Access Compliance Report

Public Rights-of-Way

(Curb Ramps)

Intersection ID: 15362	Main Street: MARNEY_AV	Cross Street: SKYLAND_AV	Location: E
ADA ID: 4F2134E09484	Ramp Type: PerpDiag	Initial Pass/Fail: Fail	Overall Compliance: No
		Severity Score: 36.25

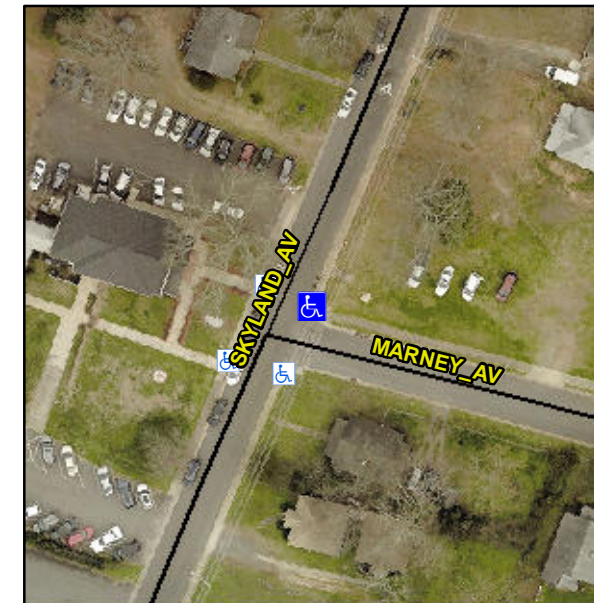
Not Found, R304.5.1, R304.5.3

Compliance	Description	Data	Compliance	Description	Data
N/A	Ramp Length (in)	55.0	Yes	Ramp Slope (%)	6.5
No	Ramp Width (in)	27.0	No	Ramp XSlope (%)	2.6
N/A	Flare Type LT	N/A	N/A	Flare Type RT	N/A
N/A	Flare Slope LT (%)	N/A	N/A	Flare Slope RT (%)	N/A
N/A	Flare Traversable LT?	N/A	N/A	Flare Traversable RT?	N/A
N/A	Landing Length (in)	N/A	N/A	DWS Provided?	N/A
N/A	Landing Width (in)	N/A	N/A	DWS Contrast?	N/A
N/A	Landing Slope (%)	N/A	N/A	DWS Length (in)	N/A
N/A	Landing X Slope (%)	N/A	N/A	DWS Full Width?	N/A
N/A	Landing Curb? (Y/N)	N/A	N/A	DWS Offset (in)	N/A
N/A	Shared Landing?	N/A			
N/A	Gutter Ponding?	N/A	N/A	Gutter Slope (%)	N/A
N/A	Gutter Lip Ht (in)	N/A	N/A	Gutter X Slope (%)	N/A
N/A	Painted X Walk1?	No	N/A	Painted X Walk2?	No
	X Walk 1 Direction	To NW		X Walk 2 Direction	To SW
N/A	X Walk 1 Width (in)	N/A	N/A	X Walk 2 Width (in)	N/A
	X Walk 1 Slope (%)	5.3		X Walk 2 Slope (%)	1.2
	X Walk 1 X Slope (%)	2.7		X Walk 2 X Slope (%)	1.7

Remove & Replace Curb Ramp With Two New Directional Ramps or Equivalent.
